D240 Discontinued

TECHNICAL BULLETIN
DATE: 29.09.16

Title: Introducing the D250 Door Frame
Ref: 900517

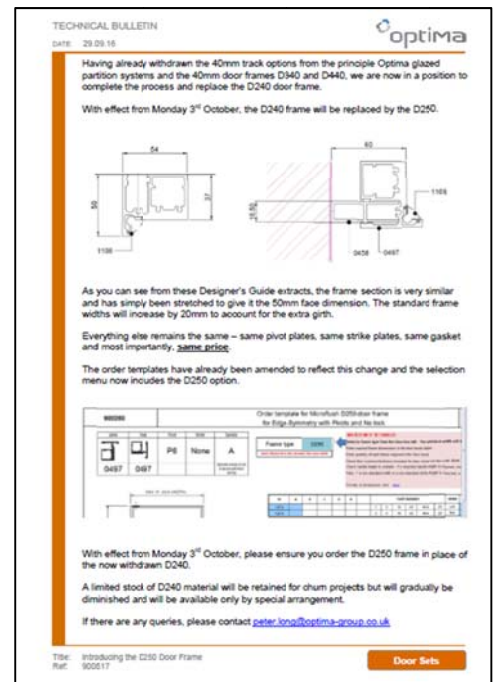
With effect from Monday 3rd October, the D240 frame will be replaced by the D250.

As you can see from these Designer's Guide extracts, the frame section is very similar and has simply been stretched to give it the 50mm face dimension. The standard frame widths will increase by 20mm to account for the extra girth.

Everything else remains the same – same pivot plates, same strike plates, same gasket and most importantly, same price.

With effect from Monday 3rd October, please ensure you order the D250 frame in place of the now withdrawn D240.

Please ensure that your projects and site set-outs are planned around the 20mm wider D250 frame and that D250s are requested on your templates and purchase orders.
